5 November 2021
Nuvis Landscape Architecture
RE: Sunset Reservoir, Pasadena

This Addendum to the 22 June 2021 report is to reflect the updated information provided. I have updated the count with three (3) additional trees and created a new list of nineteen (19) trees likely to be removed due to the new construction design (#Rxx). This Addendum should provide information on the questions raised regarding the tree recommendations. Each of these points contain views of the Plan Sheets with KJ comments and my responses for clarification.

ADDENDUM 3-17-22

This Addendum to the 22 June 2021 report is to reflect the updated information provided. It includes corrections to *Addendum 11-5-21* and replaces it. Comments in **bold** are corrections to *Addendum 11-5-21*.

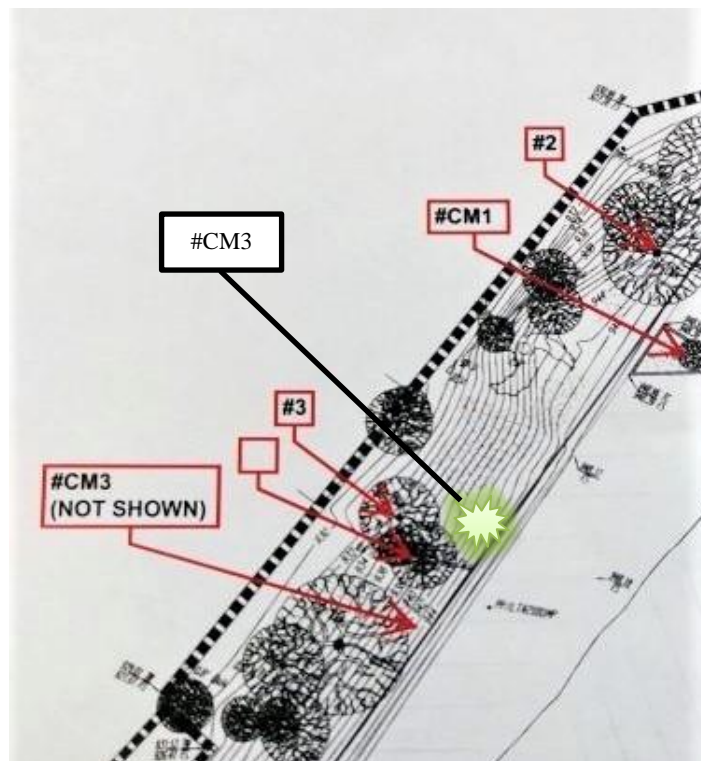
1. Correct placement of #CM3 (Sheet C-004).

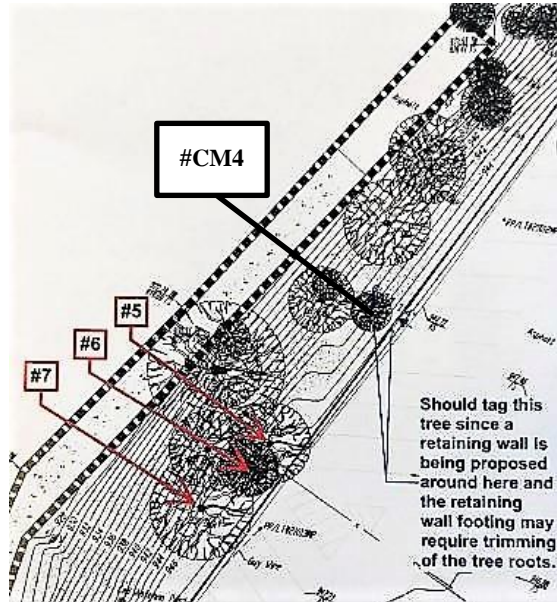
2. Added one Crape Myrtle (CM#4, Sheet C-004).

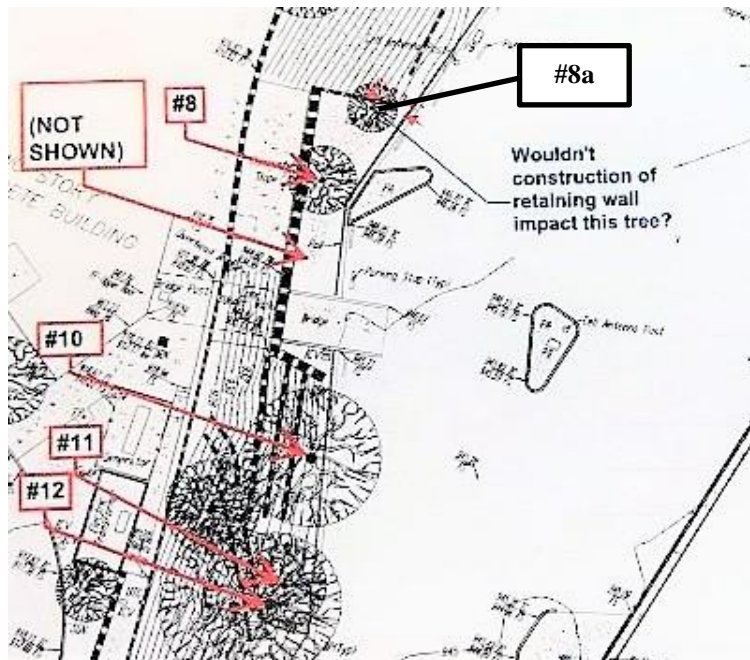
3. Added one Oak (#8a, Sheet C-005).

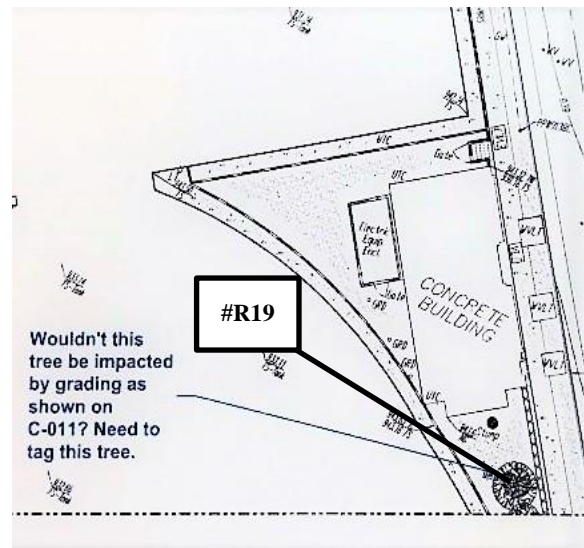
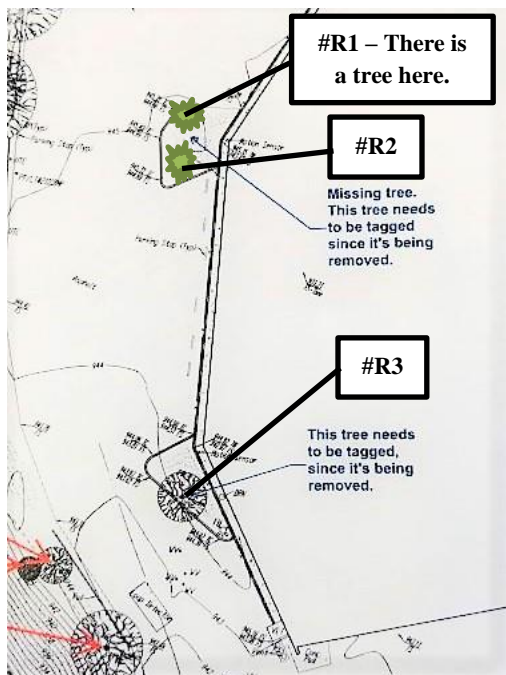
4. Confirm placement of tree #9 (Sheet C-005).

5. Three (4) trees to be removed (Sheet C-005).

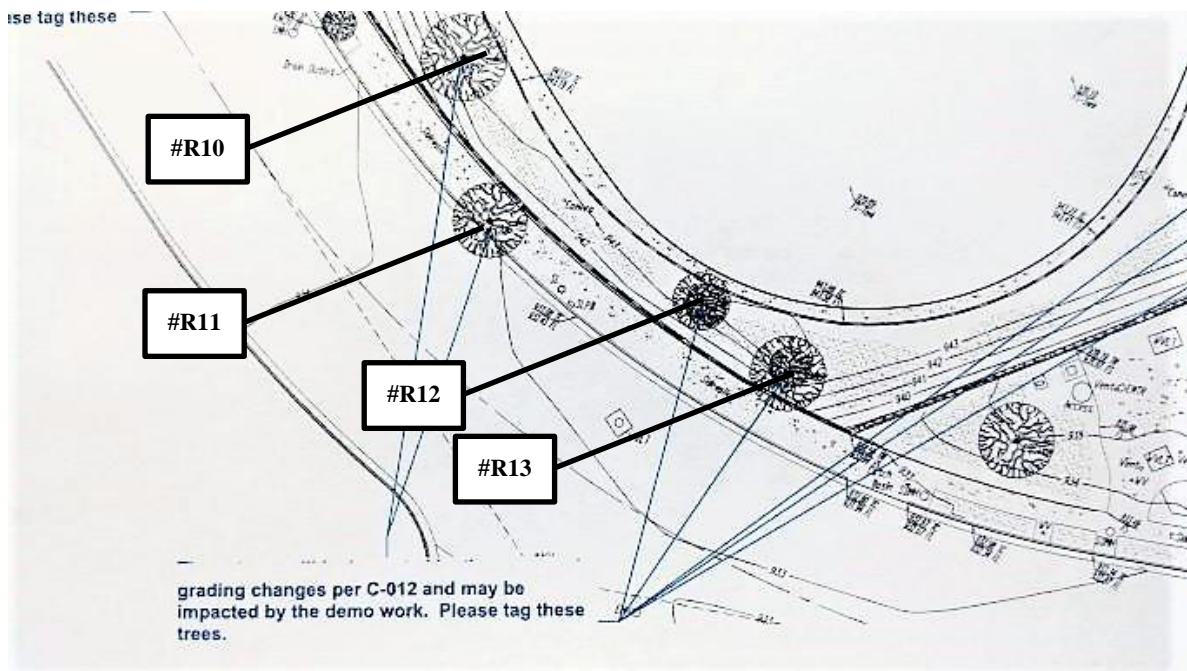
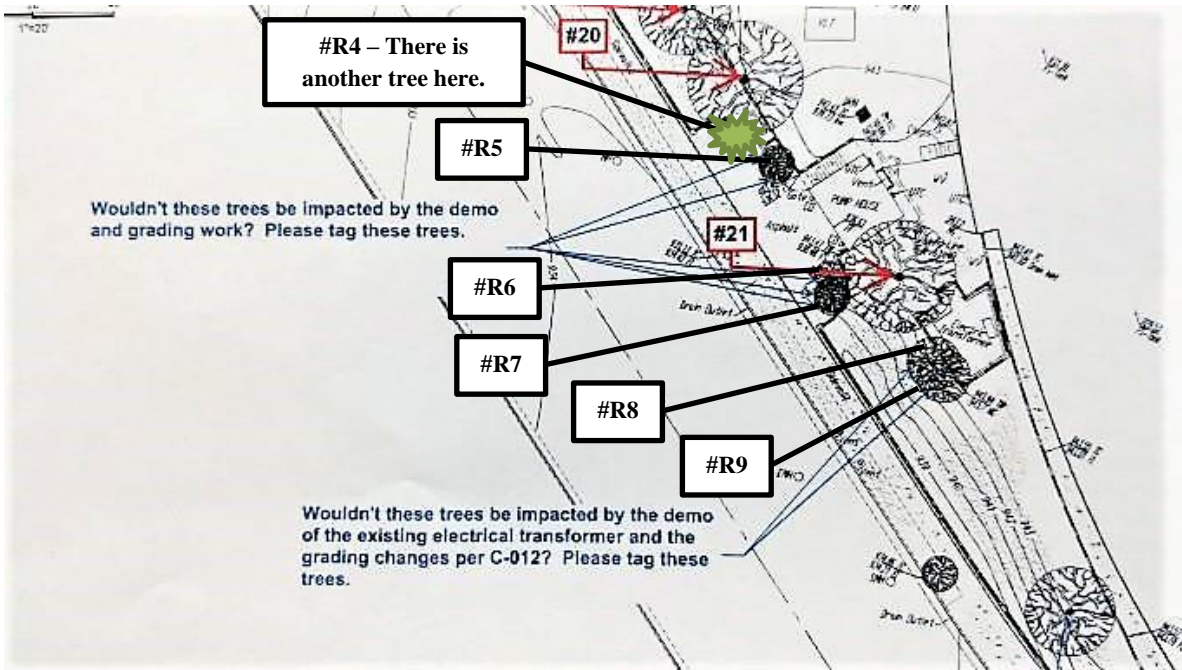
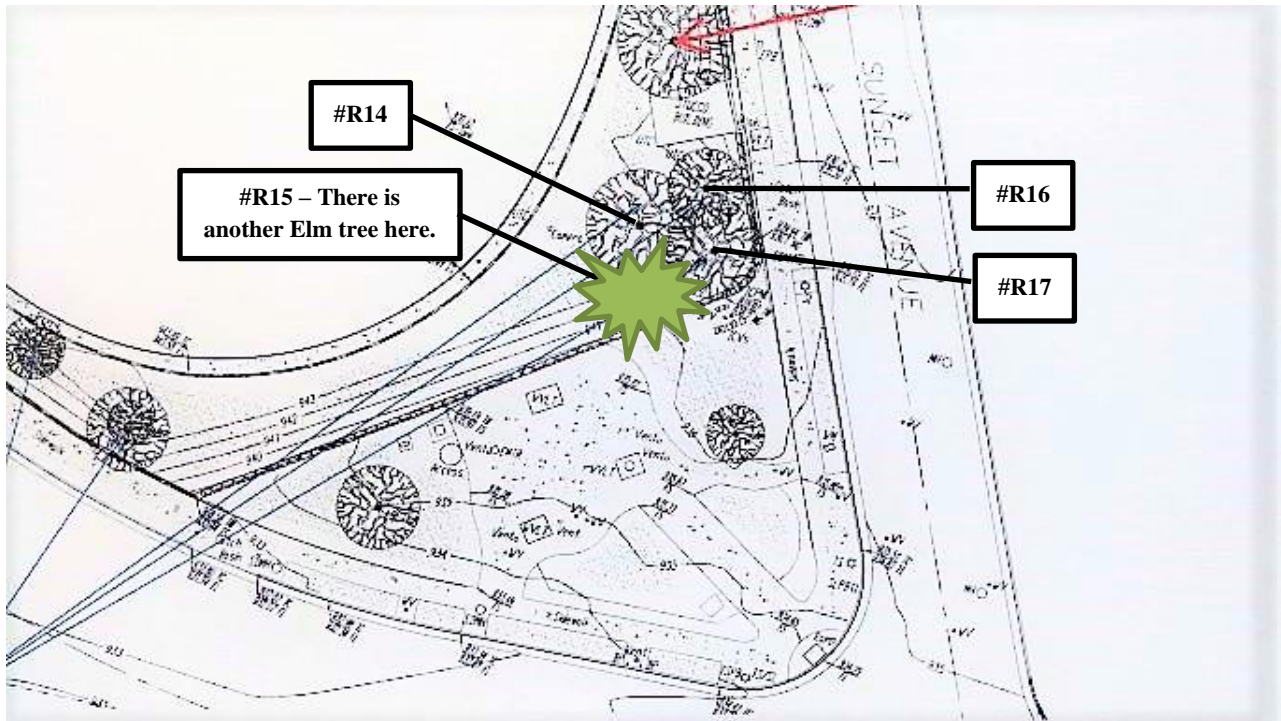
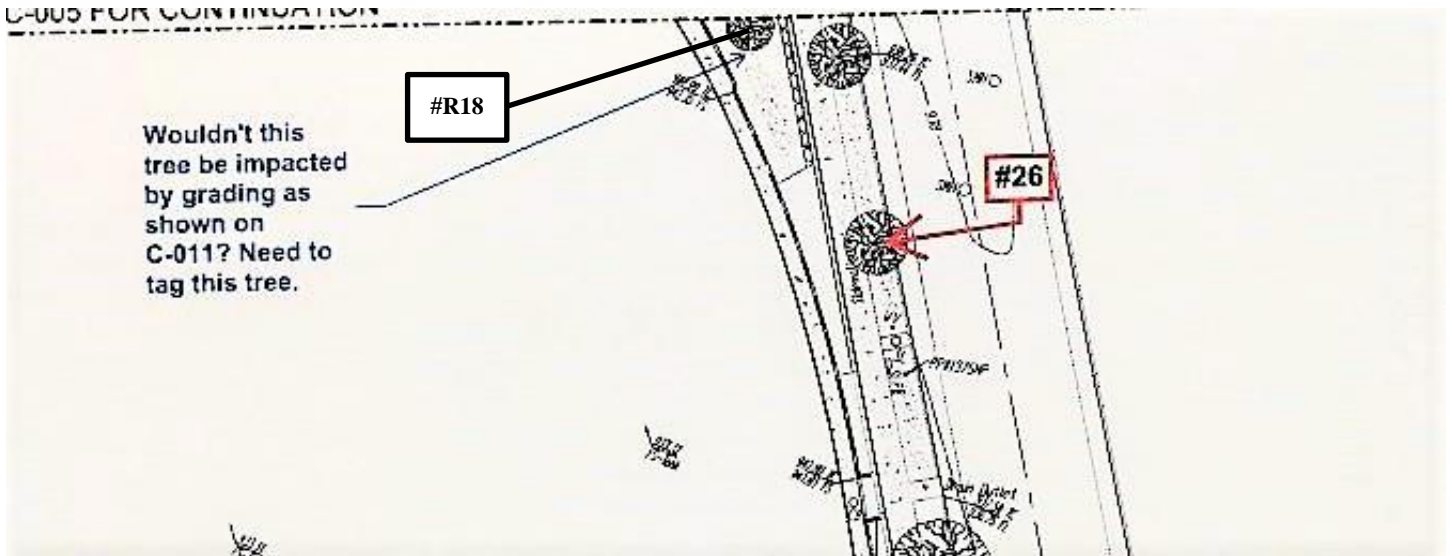
6. Sixteen (15) trees to be removed (Sheet C-006).

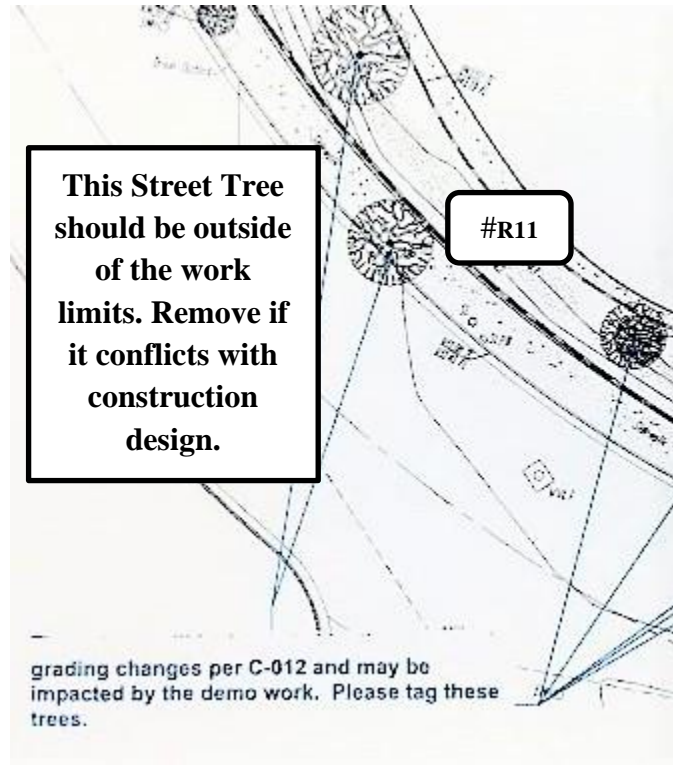
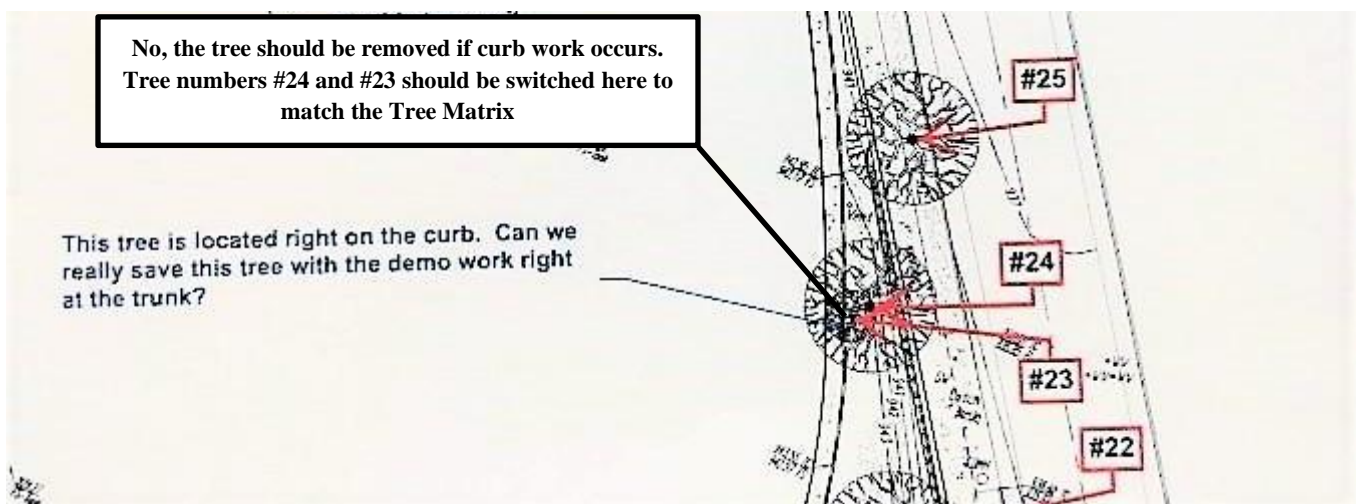
7. Comment on tagging Street Tree on Montana potentially impacted by demo work (Sheet C-006).

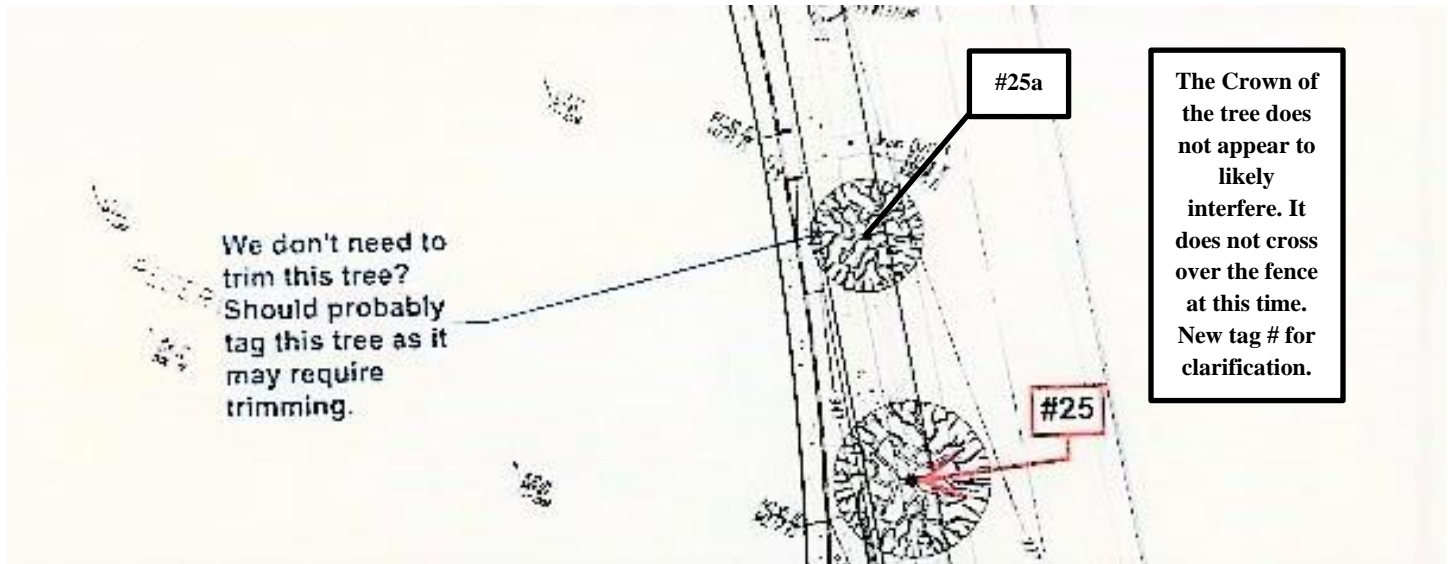
8. Comment on #24 impacted by demo work, and correct numbering (shown as #23 - Sheet C-006).

9. Comment on tagging Street Tree on Sunset potentially to be pruned (Sheet C-006).

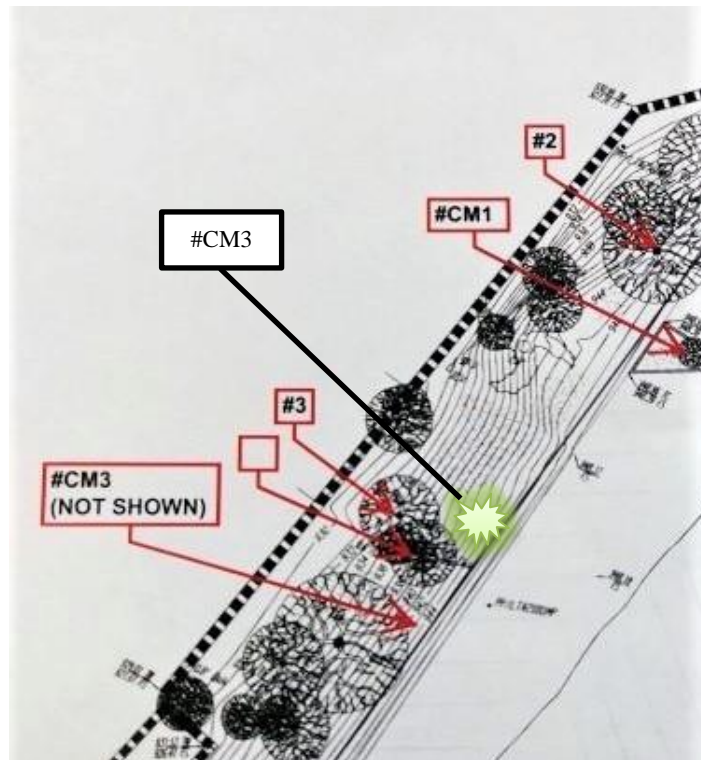
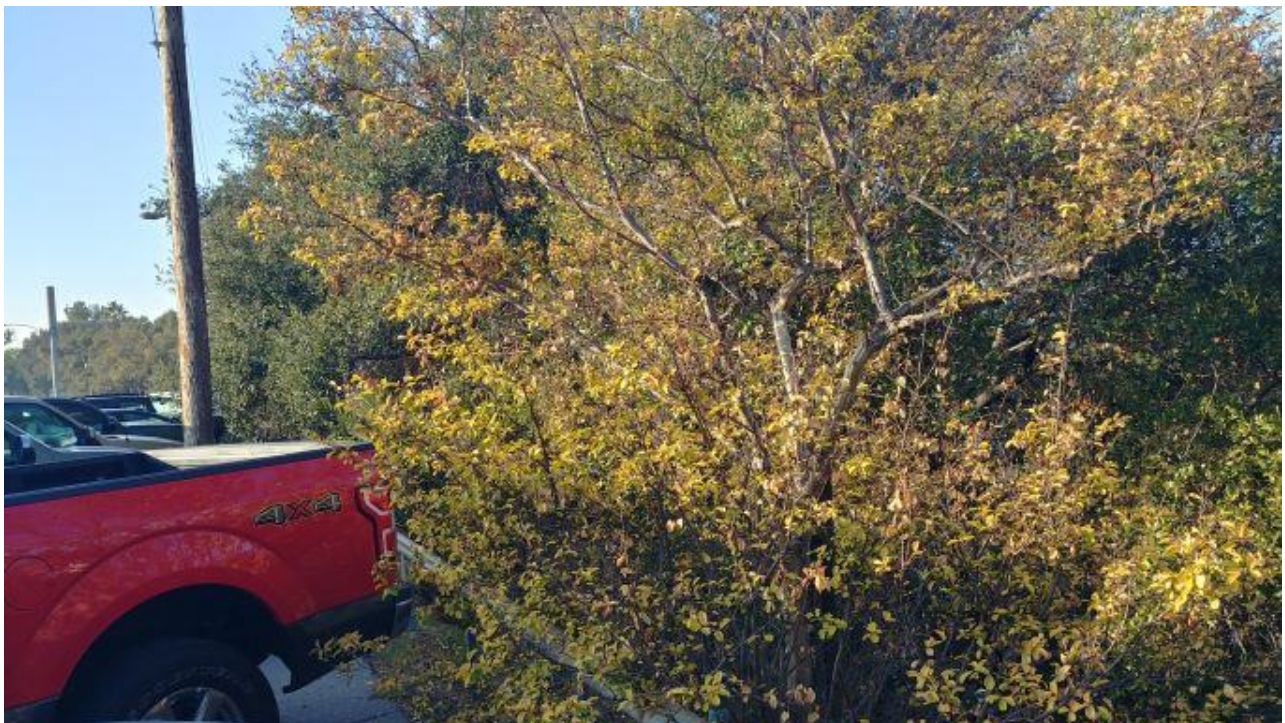
1. Correct placement of #CM3 (Sheet C-004).

(a, b). Correct photos of #CM3. Tree is in conflict with new construction.

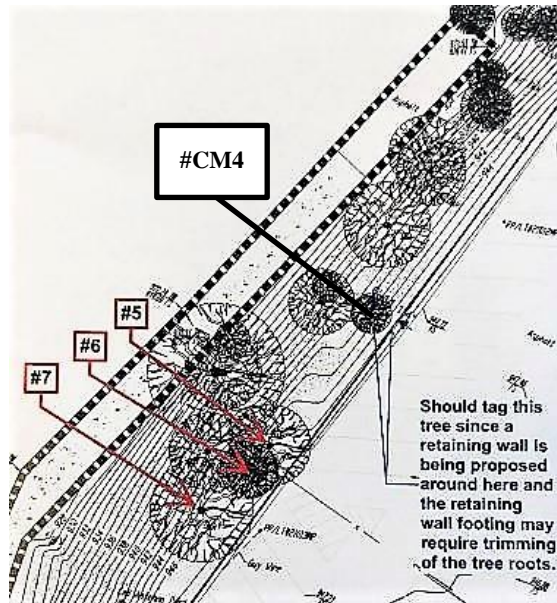
2. Added one Crape Myrtle (CM#4, Sheet C-004).

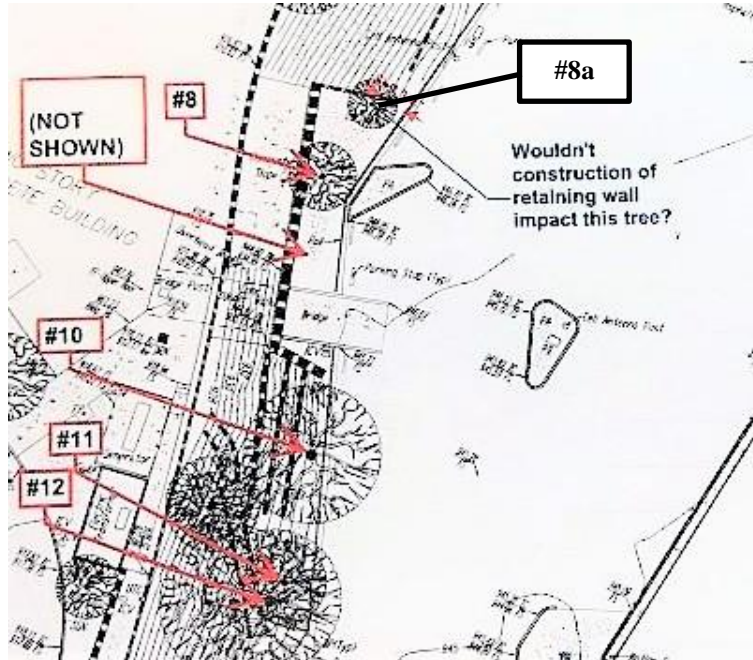
3. Added one Oak (#8a, Sheet C-005).

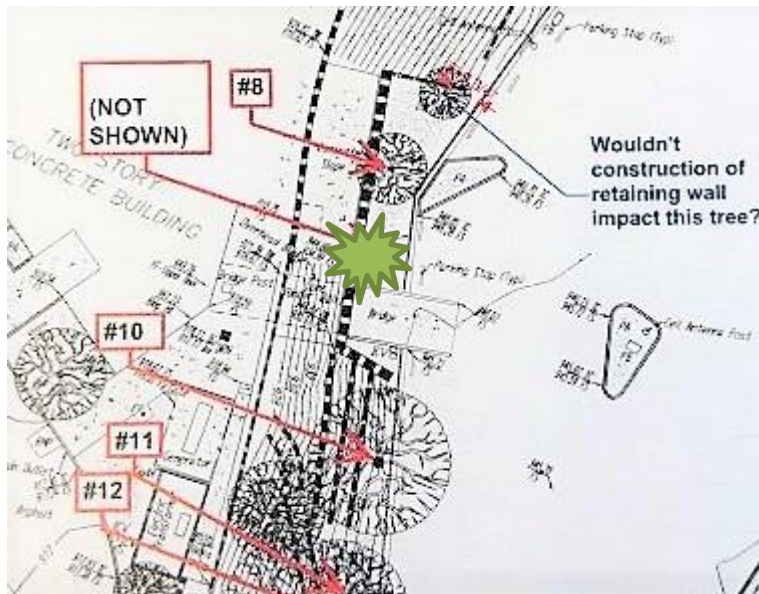
4. Confirm placement of tree #9 (Sheet C-005).

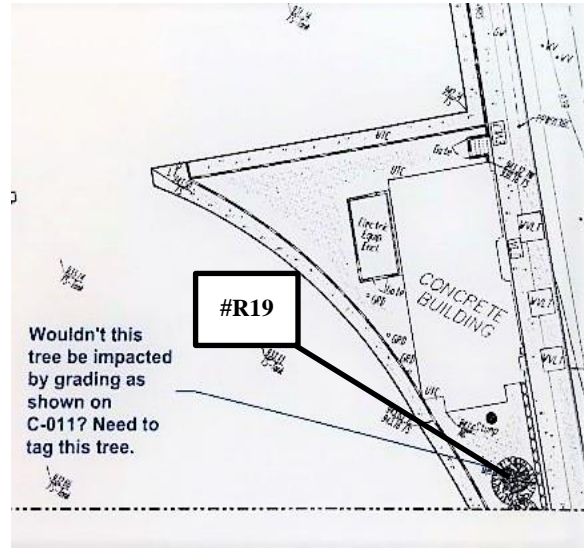
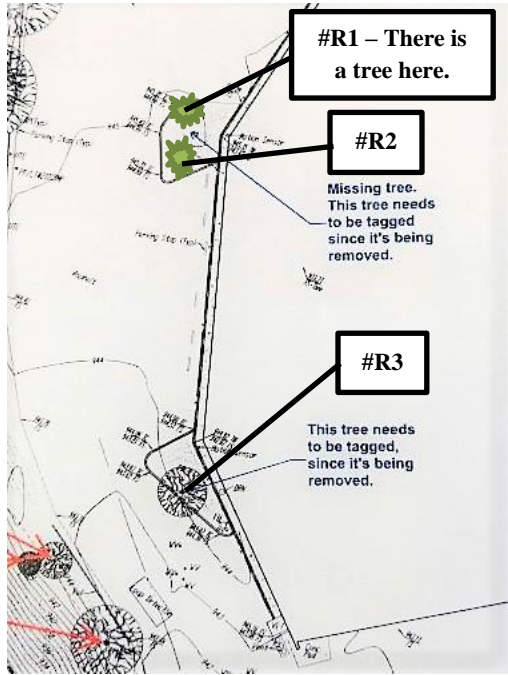
5. Three (4) trees to be removed (Sheet C-005).
